Re: St. Lucie Units 1 and 2
Docket Nos. 50-335 and 50-389
Proposed License Amendments
EDG Risk Informed AOT Extension
Request for Regulatory Commitment

REQUEST FOR ADDITIONAL INFORMATION
RELATED TO THE AMENDMENT OF THE TECHNICAL SPECIFICATIONS
FOR THE EMERGENCY DIESEL GENERATORS

ST. LUCIE UNIT 2

FIGURE 1
UNIT 1 EDG STARTING CAPABILITY CURVE

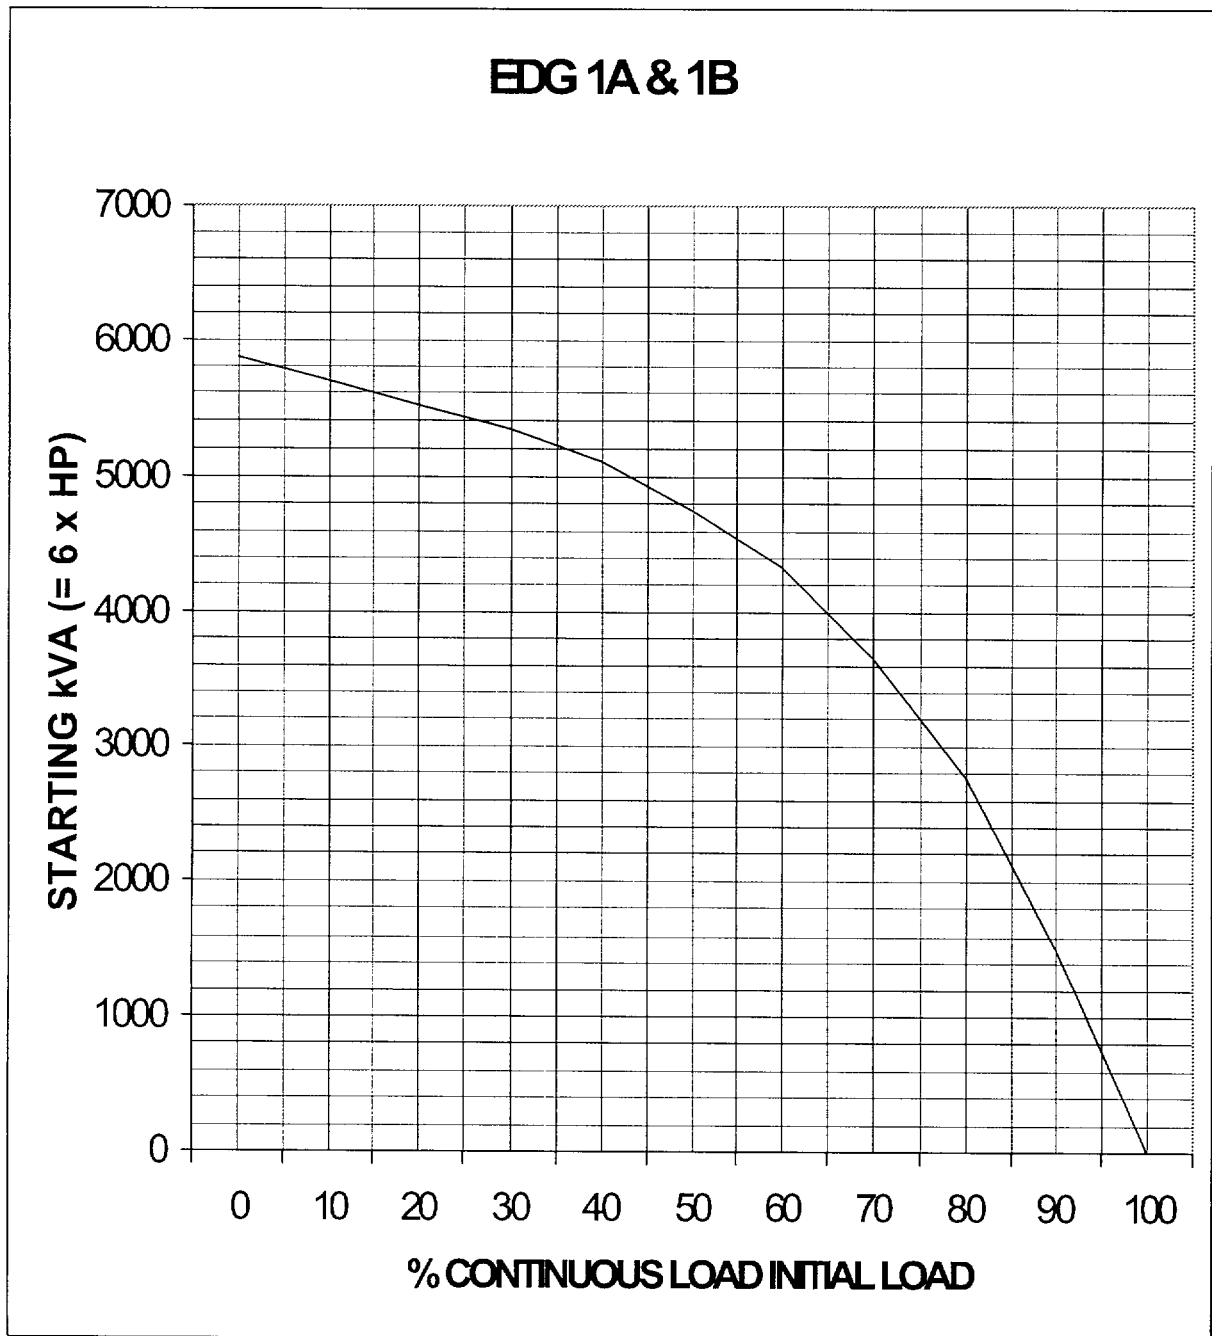
Please clarify this aspect of the design for Unit 2 in your application. In addition, indicate that the time it takes to establish this connection satisfies the availability requirements of an alternate AC source used for the SBO event.

Table 1 also provides an evaluation of the EDG capability to start the components by comparing the motor starting kVA plus non-motor kVA to the EDG motor start capability curve, Figure 1, provided by the Unit 1 EDG vendor. Component sequencing times and load values were obtained from the LOOP responses for Units 1 and 2. The evaluation ends at 120 minutes because EDG loading is reduced beyond this time.

Maximum EDG loading is 3292.4 kW at 55 minutes following closure of the Unit 1 EDG circuit breaker and establishment of the station blackout crosstie at 24 minutes following closure of the Unit 1 EDG circuit breaker. This is less than the 2000-hour rating of 3580.8 at 104°F. Loads started remain within the Unit 1 EDG load starting capability at all times, as seen by comparing the initial percent load block loading and the starting load given in Table 1 with the EDG starting capability in Figure 1.

The maximum loading applied to the Unit 1 diesel generator, given a Unit 2 station blackout with one operable Unit 1 EDG, is 3292.4 kW (at 55 minutes following closure of the Unit 1 EDG circuit breaker and establishment of the station blackout crosstie at 24 minutes following closure of the Unit 1 EDG circuit breaker). This is less than the Unit 1 EDG 2000-hour rating of 3580.8 kW at 104°F with a margin of 288.4 kW. It is also less than the Unit 1 EDG continuous rating of 3360kW at 104°F. Loads started in the various time blocks remain within the starting capability of the Unit 1 EDG at all times.
